# Product Support Bulletin 2009-018A

## Maintenance of Way ~ Work Equipment Bulletin

**DATE:** December 4, 2009  
**SUBJECT:** Possible Defective Electrical Interlock Relay – 61231200 (12-volt) and 61231201 (24-volt)

**Figure 1**  
Typical Electrical Interlock Relay  
12-volt 61231200  
24-volt 61231201

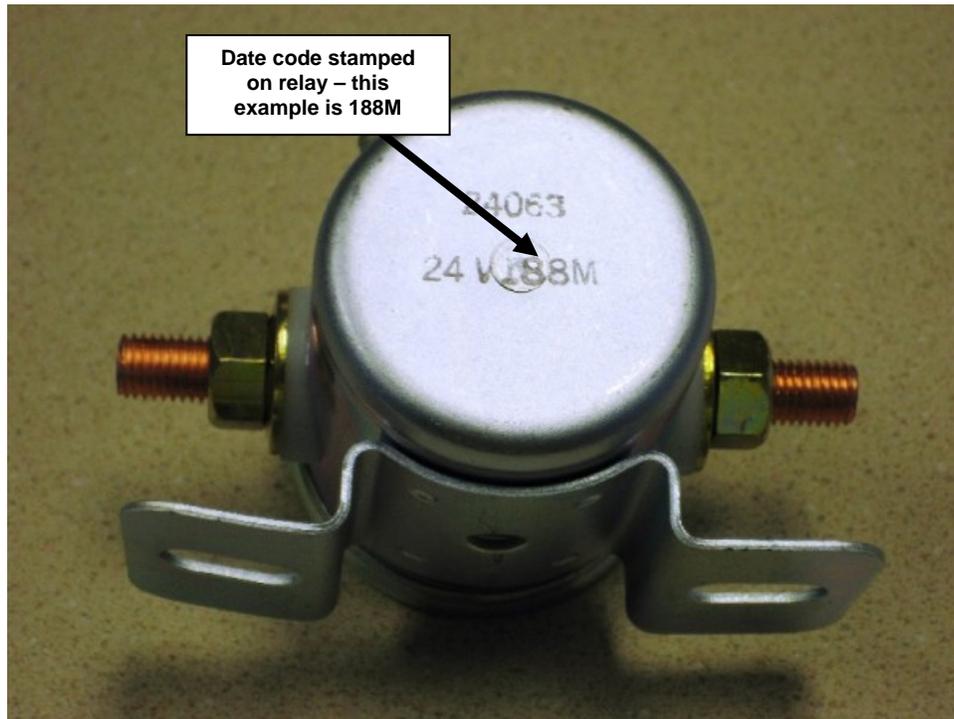
**ACTION:** The relays have a date code stamped on the housing of the relay; see Figure 1 on Page 2. The date code signifies the week and year of manufacture; the example shown in Figure 1 was manufactured the 18<sup>th</sup> week of 2008. **DEFECTIVE RELAYS WILL HAVE DATE CODES OF 085M THROUGH 195M INDICATING THEY WERE MANUFACTURED FROM THE 8<sup>TH</sup> WEEK OF 2005 THROUGH THE 19<sup>TH</sup> WEEK OF 2005. THE RELAYS IN ALL MACHINES SHOULD BE CHECKED AND ANY RELAYS FOUND WITH A DATE CODE IN THIS RANGE MUST BE REPLACED. ONLY RELAYS WITH DATE CODES ENDING IN 5M ARE DEFECTIVE.** Consult your Operator's/Parts Manual for the location of the relay on your particular machine or contact the Nordco Service Department at 1-800-445-9258 for assistance. See Figure 2 on Page 2 for a typical relay location.

**WARRANTY:** Nordco will replace any relays with date codes from 085M through 195M under warranty until December 31, 2009. Please contact the Nordco Service Department at 1-800-445-9258 for a replacement. You will be required to provide a machine serial number and you will also be required to return the defective relay to Nordco. A return authorization number will be issued to you when your order is placed.
